Subject: FW: SUB23/0066 LUC23/0121 Melrose Road - RFI

Subject: SUB23/0066 LUC23/0121 Melrose Road - Request for further information

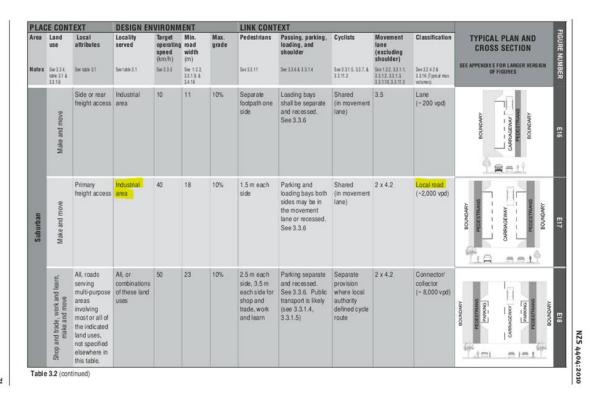
4m lane widths probably won't be sufficient to allow for on-street parking given the larger trucks that will operate through here. I also don't see any street trees, Open Spaces will require street trees on both sides of the road and the swale will require batters of 1:5 to allow for safe mowing.

Given the above, the design may need to be adjusted, perhaps as mentioned in the memo, the stormwater should rather be piped than conveyed via swale. Have you got meeting notes for this Nicholas? I have got some notes on roading but can you draft up conditions in line with the discussion. That includes some trees along the road, stormwater shall be via a swale or piped in accord with NZS4404 etc

I see that a 2.5m wide shared path is proposed on one side of Melrose Road. This is a good idea in this location. Would the path be on the south or north side of Melrose Road? Footpath one side as I understood it was to be the west side? Can you confirm

I assume the 20m is the legal width? This won't allow a swale system to treat/convey stormwater. Will stormwater be piped? How will this be treated and disposed of in accordance with our Global Consent CRC186263?

In terms of the roading upgrades, Glen McLaughlin and Selwyn Chang, from Davis Ogilvie, had provided the proposed cross-sections with the initial design (namely Sections A, B & C shown on plan PLO3) were for the new internal roads.

The Novo Group report noted that Melrose Road would be upgraded to an Industrial 'Local Road' standard, including widening of the road corridor to 20m.

To keep it simple at this stage, Council's nominated standards, in this case Figure E17 from Table 3.2 contained within NZS4404:2010, are relevant. With the 20m road corridor that is going to be available in Melrose Road, please see below the Industrial 'Local Road' standard that would apply.

A typical cross section has been drafted showing the above
